## ADDENDUM #4

Date: April 19, 2019

**Technical Career Center Addition  
Star Valley High School  
Lincoln County School District No. 2  
Afton, Wyoming**

A SITE PLAN  
SD1.2 SCALE: 1" = 10'-0"

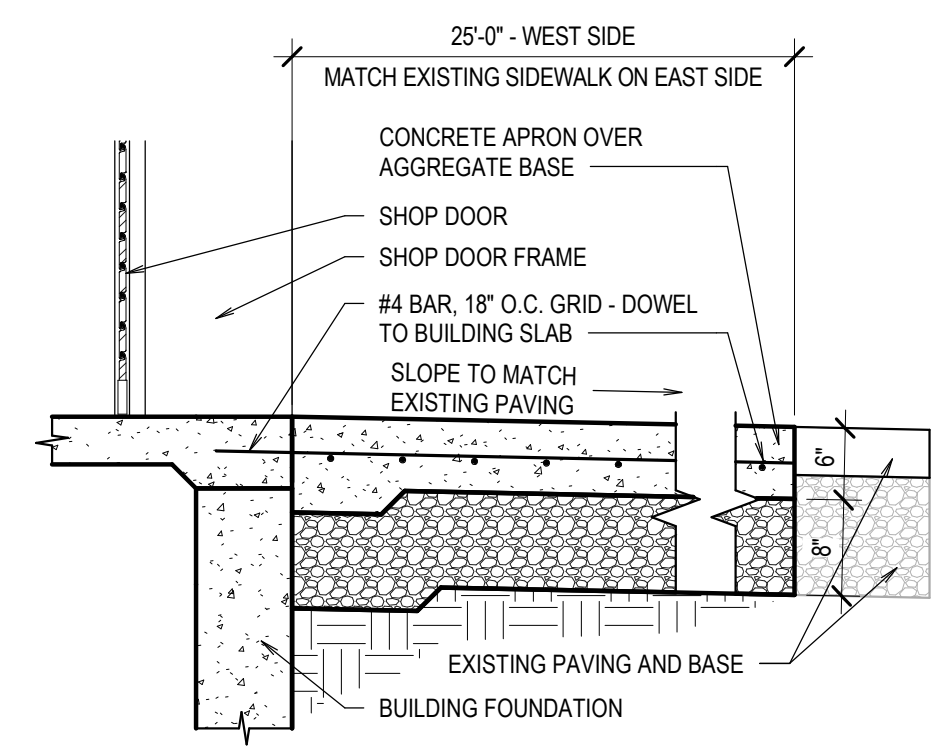
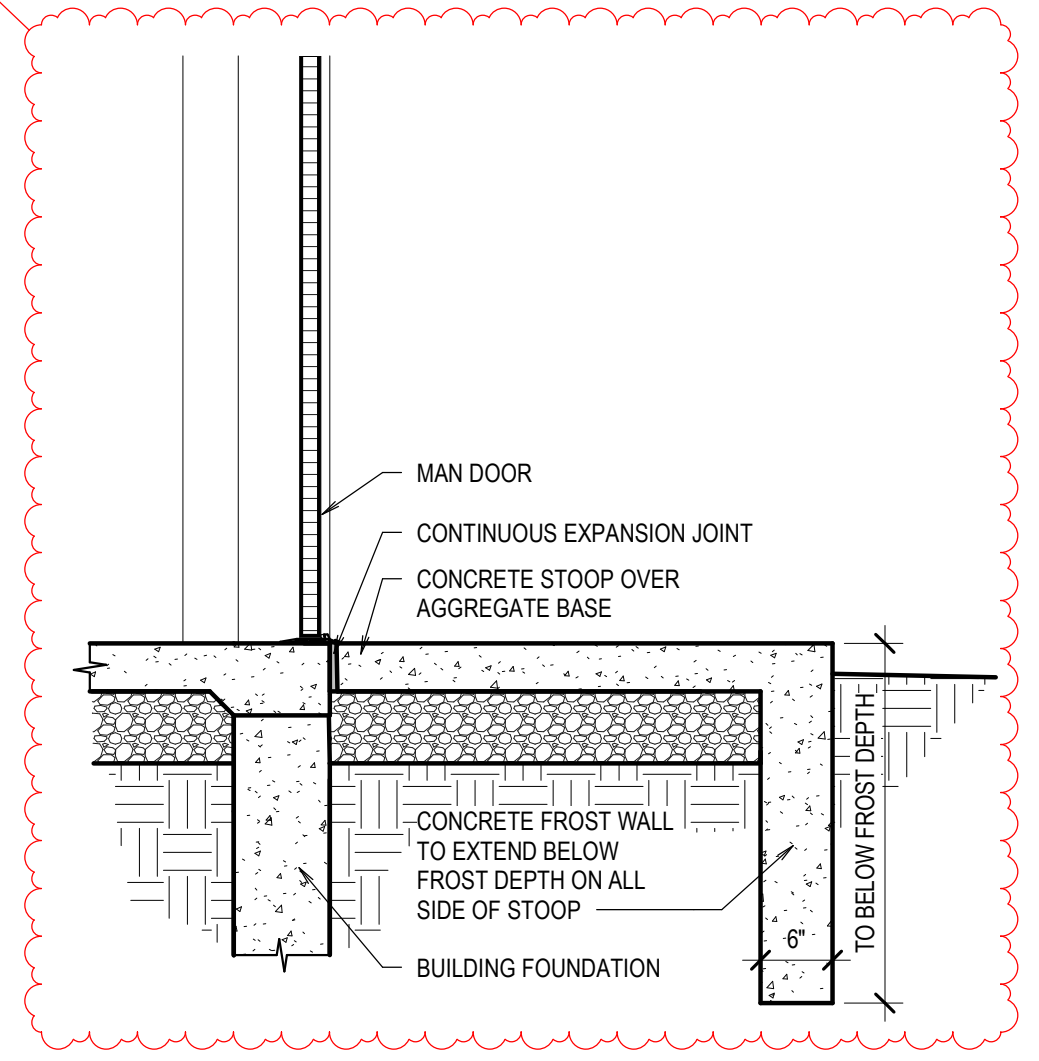
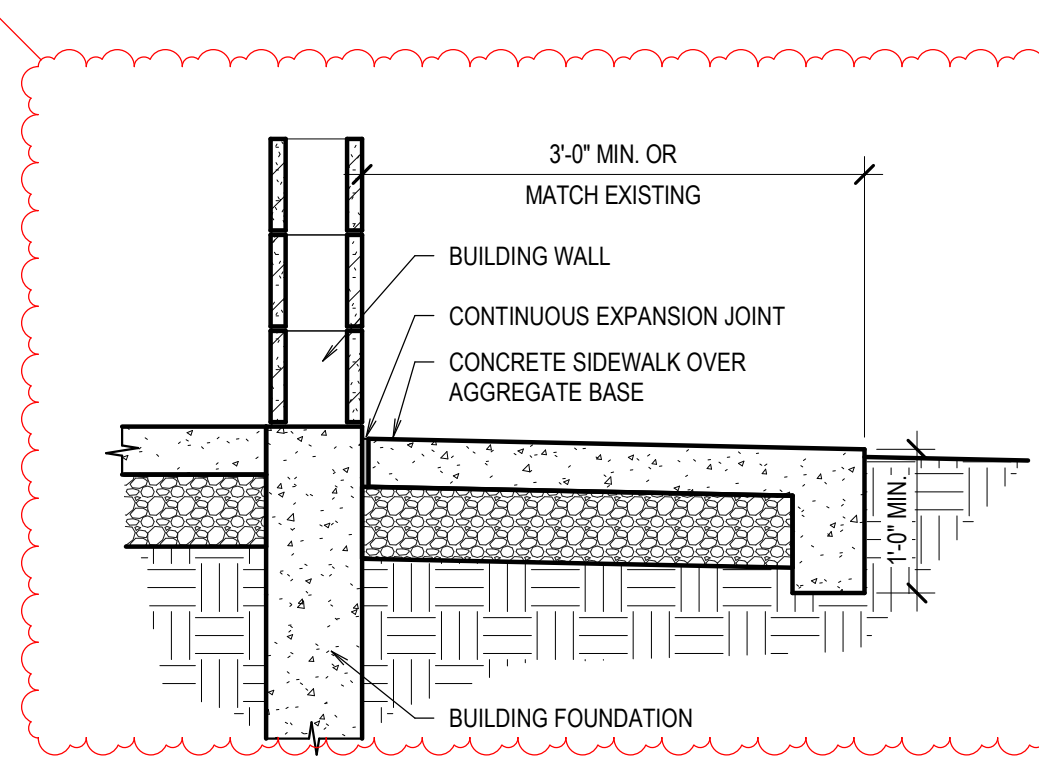
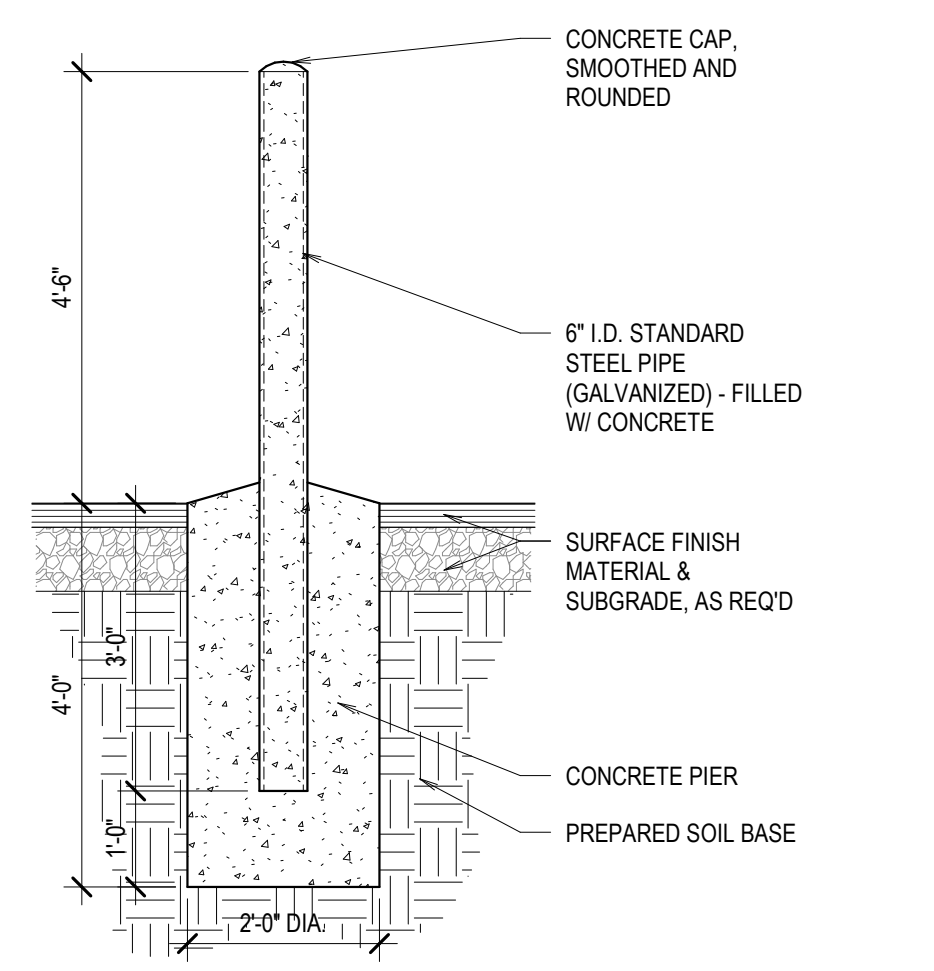
1. See revised Sheet **SD1.2 – Enlarged Site Plan**
  - a. Roof Drain piping information.

**STEEL JOIST AT MASONRY WALL**

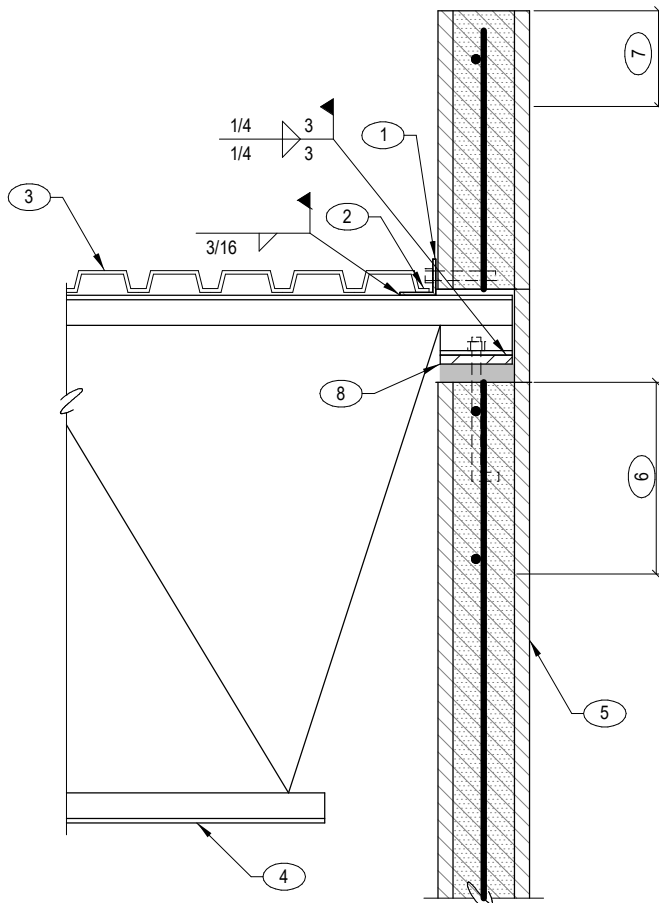
Detail 201	Bearing plate anchorage per keynote 8, contractor may substitute the anchor bolts with headed studs. See attached detail.
Section 05 1200, Part 3.2, subsection B. 2.	Section shall read as follows: Promptly pack grout solidly between bearing surfaces and plates so no voids remain. Neatly finish exposed surfaces; protect grout and allow to cure <i>to minimum 3500 PSI compressive strength</i> . Comply with manufacturer's written installation instructions for shrinkage-resistant grouts.

1.	CONT L3x3x 1/4 STEEL ANGLE W/ 3/8" DIA CONCRETE ANCHOR W/ 5" MIN EMBEDMENT AT 32" O.C.
2.	BOUNDARY ATTACHMENT, SEE PLAN
3.	STEEL DECK, SEE PLAN
4.	STEEL JOIST, SEE PLAN
5.	MASONRY WALL, SEE PLAN
6.	16" DEEP BOND BEAM W/ (2) #5 BARS CONTINUOUS
7.	8" DEEP BOND BEAM W/ (1) #5 BAR CONTINUOUS AT TOP OF PARAPET
8.	3/4"x6"x1'-0" BEARING PLATE W/ (2) 3/4" DIA x 12" LONG ANCHOR BOLTS ON ±1/2" NON-SHRINK GROUT OR
	3/4"x6"x1'-0" BEARING PLATE W/ (2) 3/4" DIA x 12" LONG HEADED STUDS ON ±1/2" NON-SHRINK GROUT

**STEEL COLUMN AT FOUNDATION**

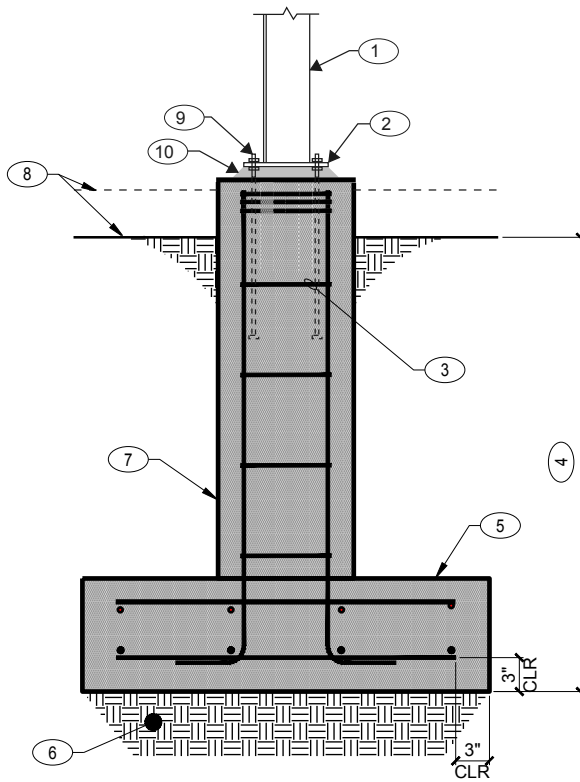
Attached detail	Contractor to provide concrete foundations at locations to support existing dust collector columns

1. EXISTING STEEL COLUMN
2. EXISTING BASE PLATE
3. #3 TIES AT 8" O.C. W/ (3) IN TOP 5" OF PIER
4. MINIMUM FOOTING DEPTH, SEE GSN
5. 48"x48"x12" THICK CONC FOOTING W/ (4) #4 BAR EACH WAY TOP & BOTTOM
6. COMPACTED SUB-GRADE BELOW FOOTING, SEE PLAN
7. 18"Ø CONCRETE PIER W/ (6) #5 BARS VERTICAL
8. SIDEWALK, PAVEMENT, OR FINISH GRADE PER ARCH
9. HEAVY HEX BOLT F1554 GR. 36 W/ 14" MIN EMBEDMENT, MATCH LAYOUT AND DIAMETER OF BOLTS OF EXISTING BASE PLATE LAYOUT
10. ±1½" NON-SHRINK GROUT
